Bidder acknowledges receipt of and has added to and made a part of the proposal and contract documents the following addendum (addenda):

- 1 Revised Table of Contents; Revised NTB Nos. 937, & 938; Added NTB Nos. 986, 987, 1029, & 1030; Revised Wage Rates; Revised Bid Items; Revised or Added Plan Sheet Nos. 2, 7-10, 12-24; Amendment EBS Download Required.

PROJECT: NH-0055-02(248)/102315302 - Madison

SECTION 904 - NOTICE TO BIDDERS NO. 937

MISSISSIPPI DEPARTMENT OF TRANSPORTATION TYPICAL SECTIONS			
I-55 NORTHBOUND			
STA. 528+00.47 TO STA. 543+27.17			
COUNTY: MADISON			
PROJ. NO.: NH-0055-02(248)			
FILENAME:			
DESIGN TEAM	HNTB	CHECKED	RLG
DATE	5/7/18		
WORKING NUMBER			TS-6
SHEET NUMBER			12

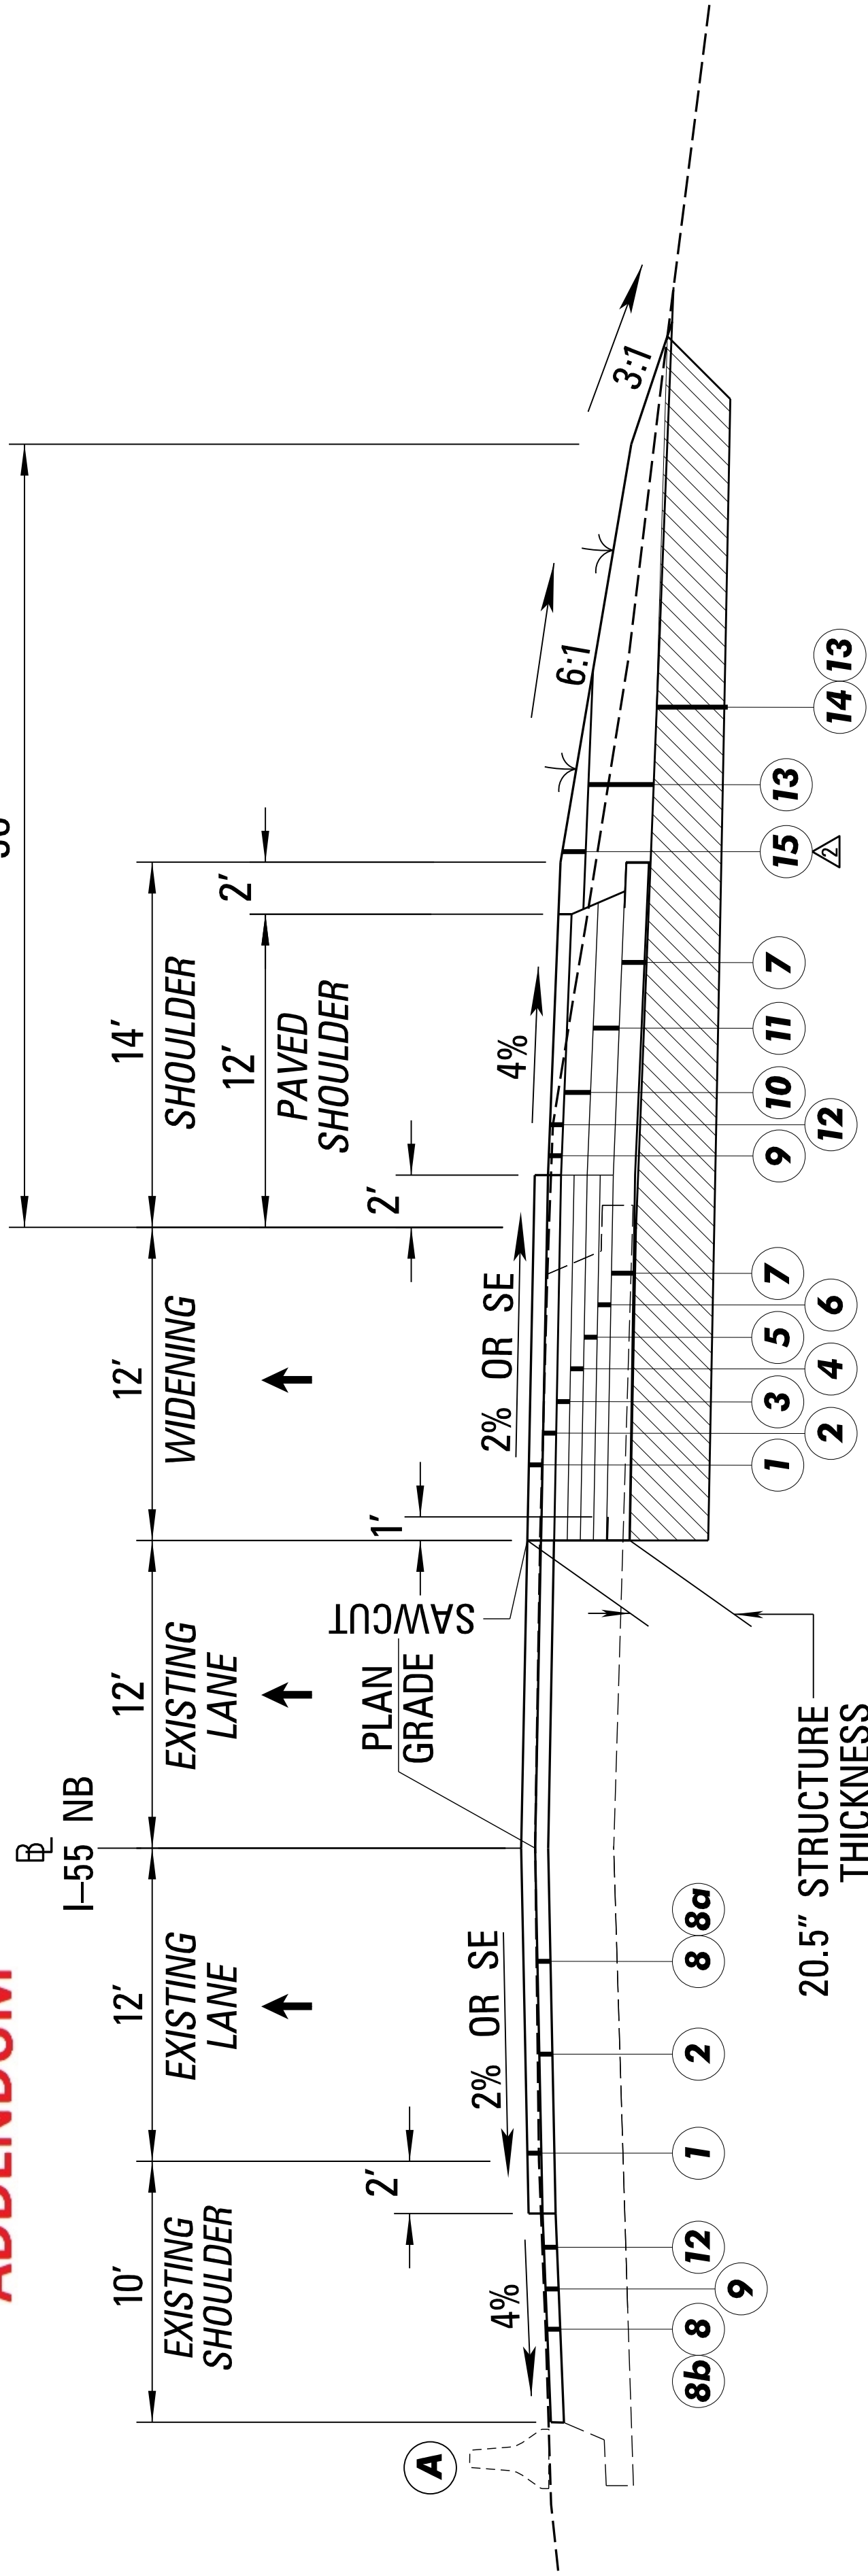
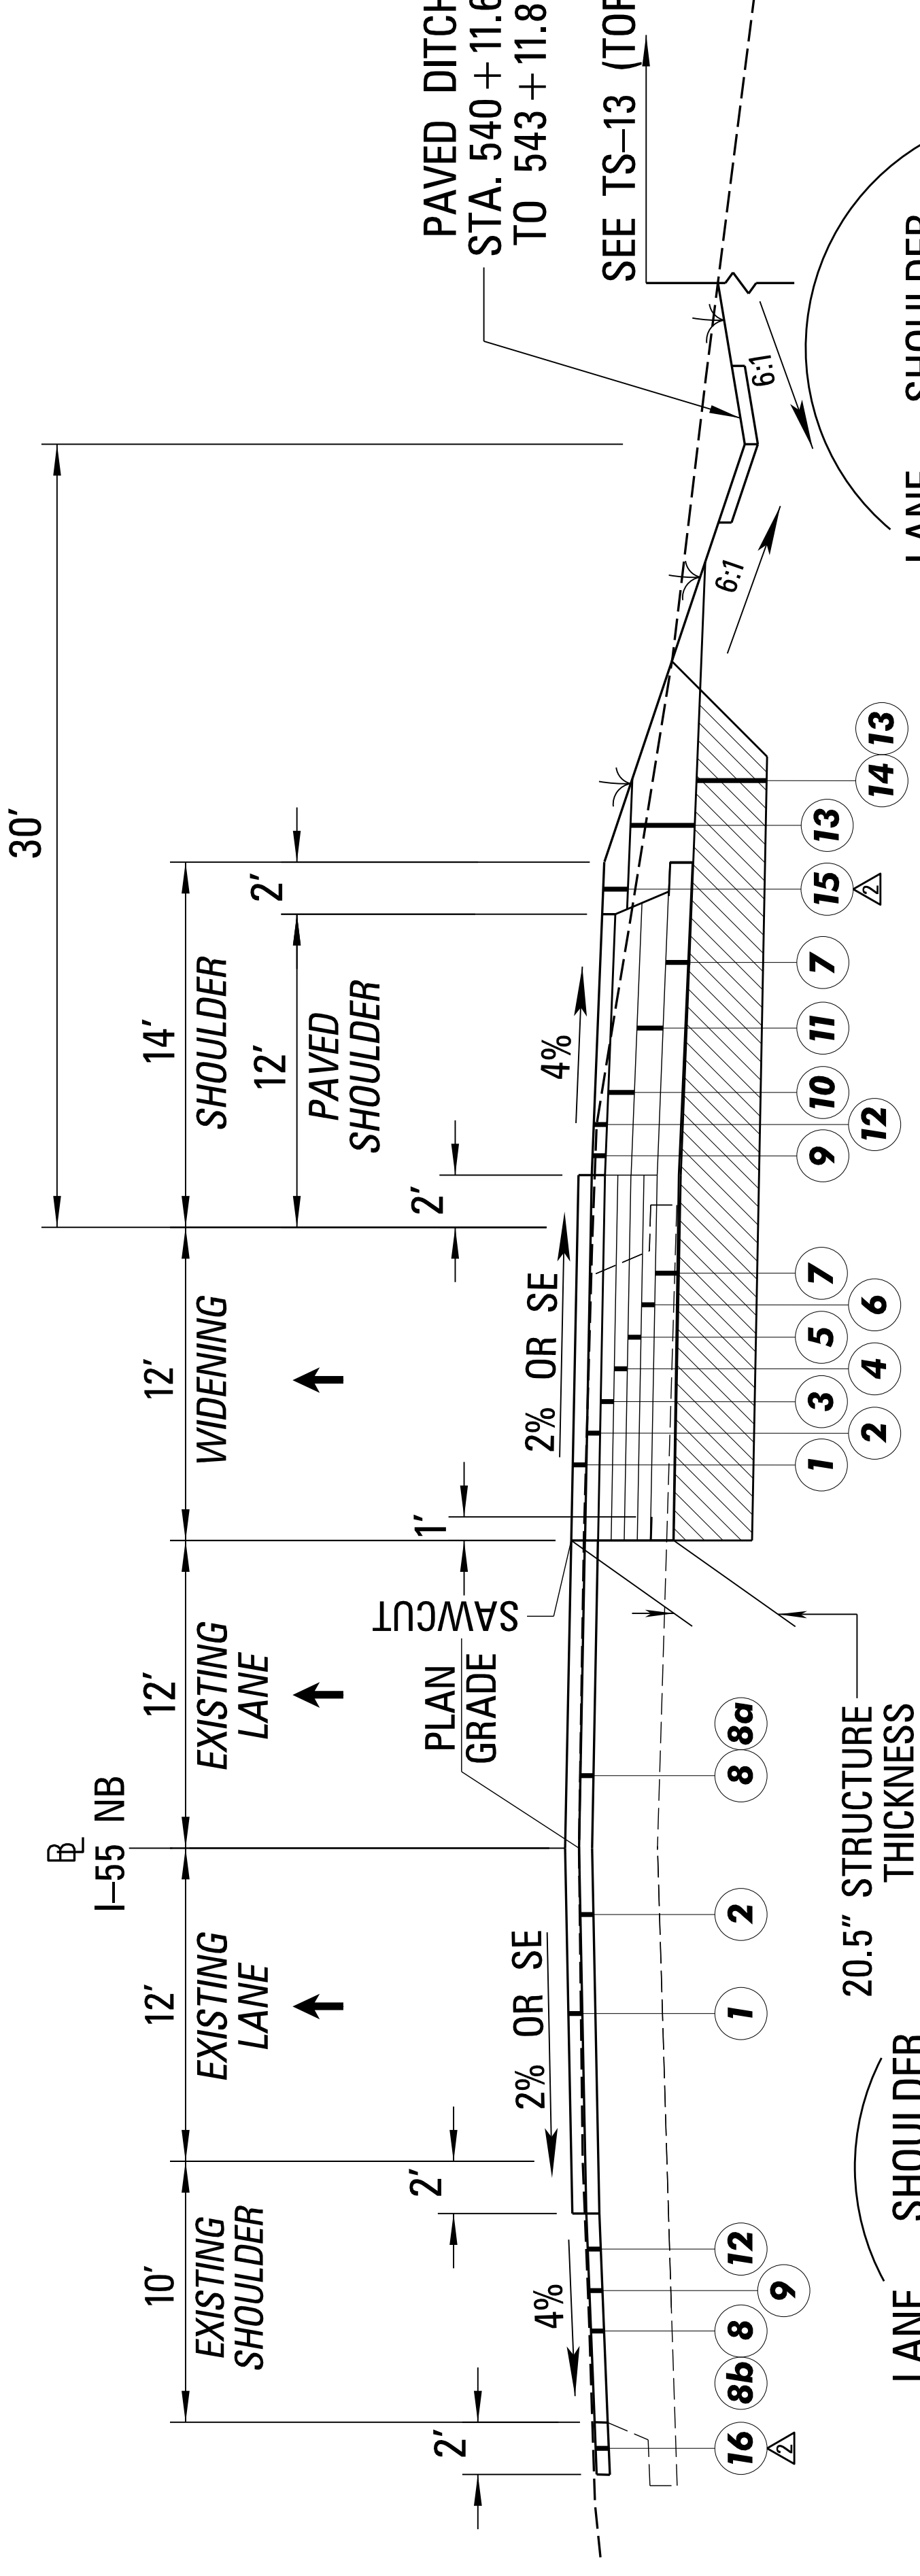
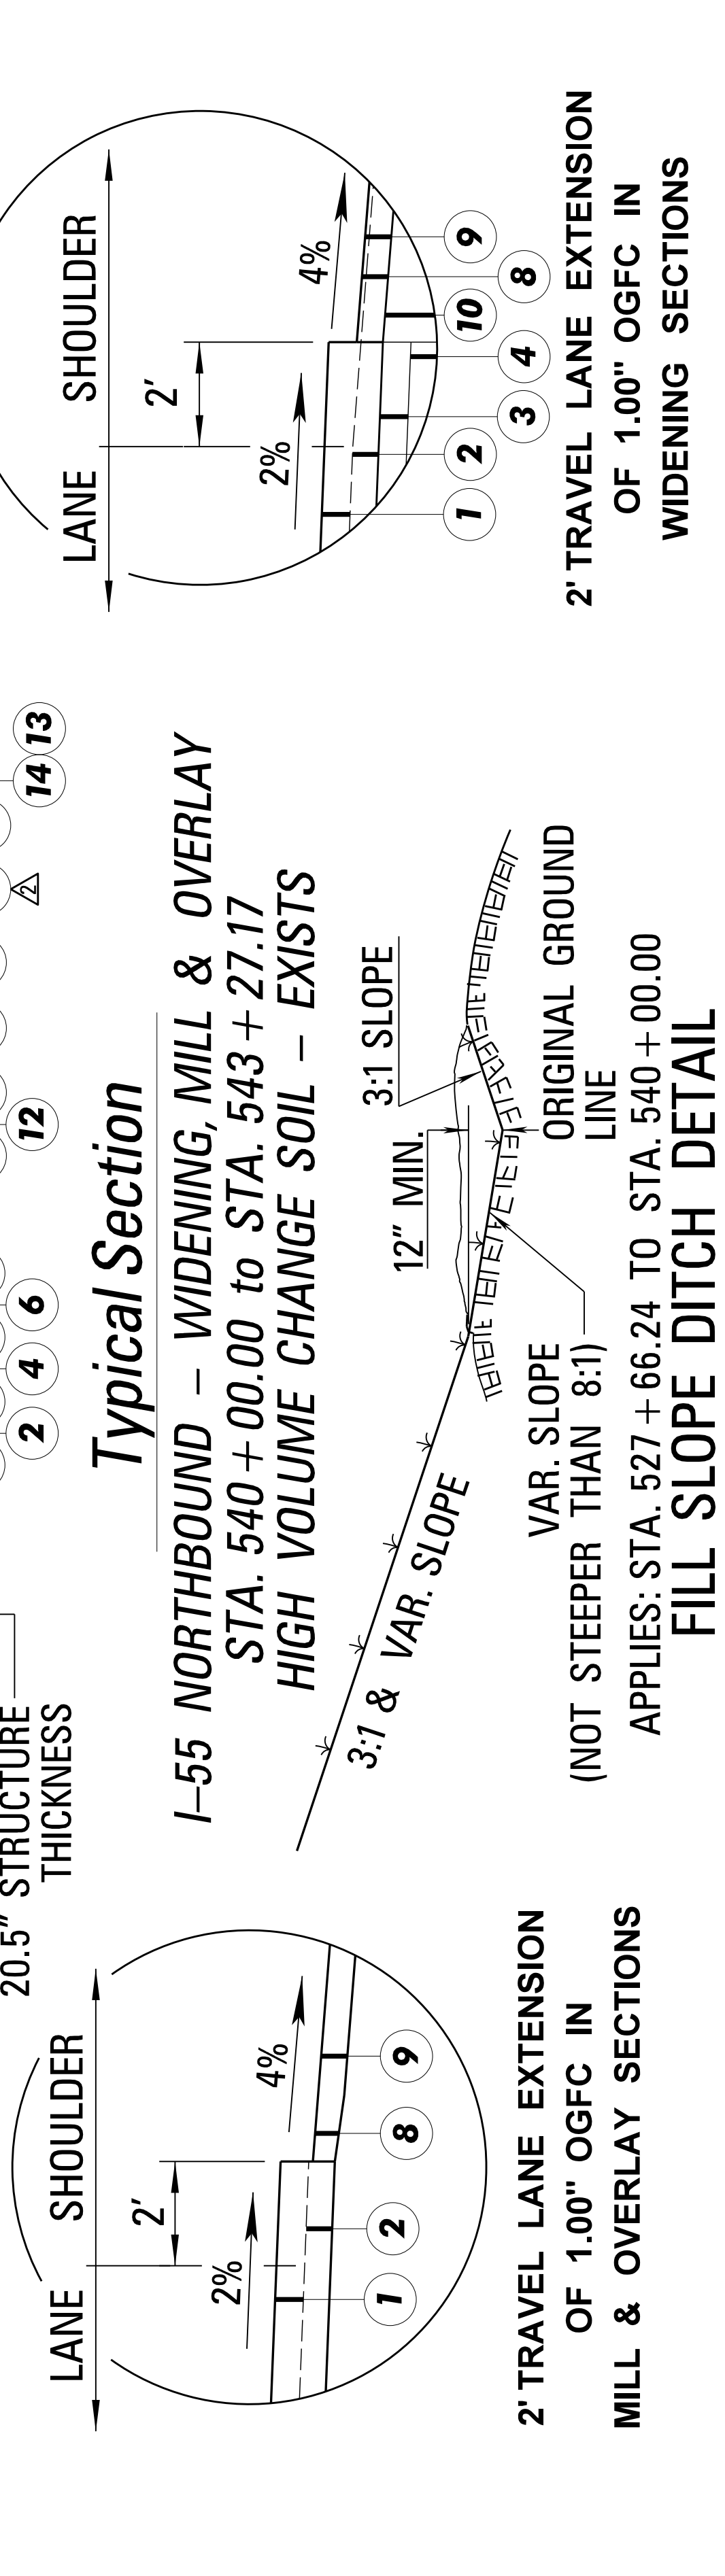
7-13-18	ADDED GRANULAR MATERIAL	KBP	KBP	REVISION
6-15-18	ADDED NOTE FOR LEVELING HT MIX	KBP	KBP	REVISION
DATE	BY
